SAFETY RECALL

SR15-52

DATE :	NOVEMBER 2015	SECTION :	16 - Suspension
SUBJECT:	5 th Bar attachment studs on IFS suspension

Overview of the vehicle 5th bar and studs to be removed.

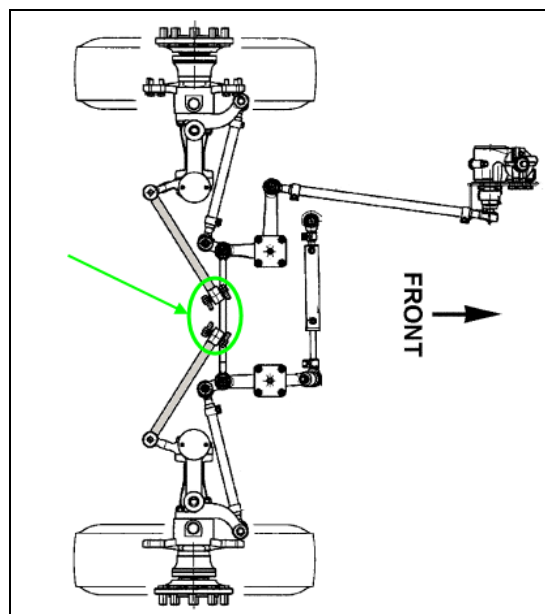
On vehicles affected by this recall, the studs used in the independent front suspension (IFS) to attach the suspension 5th bar (torque rod) to the vehicle frame may not meet their ISO specification and may have an ultimate yield strength lower than required by the design specification.

If the studs fail, the wheel may pivot toward the braking force direction, increasing the risk of a vehicle crash.

Consequently, all vehicles involved must have their 5th bar studs and related hardware replaced free of charge.

Double nutting the stud to tighten : 100lb-ft (finish with torque wrench).

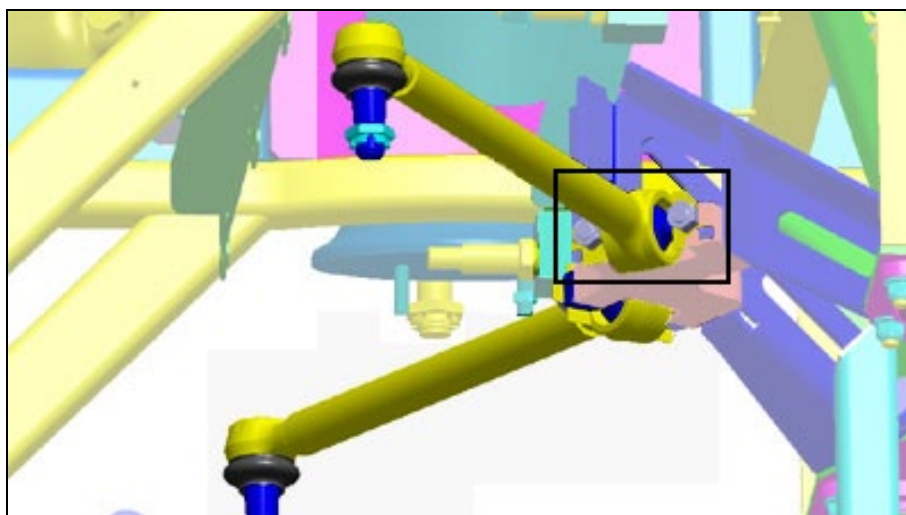
9. Using the double nut technique (double nutting), torque the new studs to 100lb-ft.

Reinstall bar, lock with cotter pin.

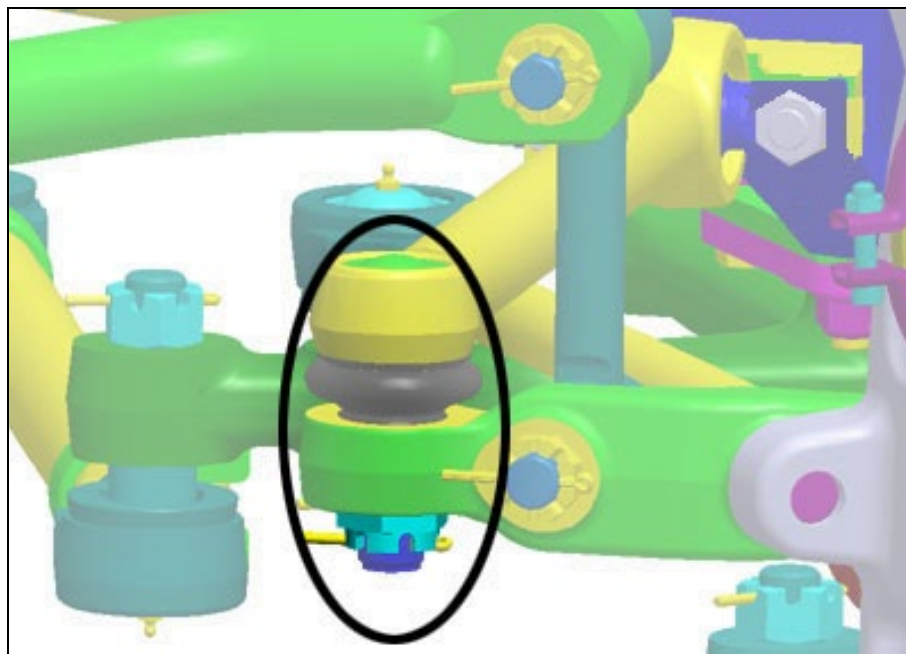
12. Reconnect the bar at the suspension side, torque the castle nut to 150lb-ft.
13. Install the supplied cotter pin to lock the castle nut.

If the cotter pin hole and the castle nut do not line up, tighten the castle nut to next aligning cotter pin slot. Do not unscrew or go below 150lb-ft.
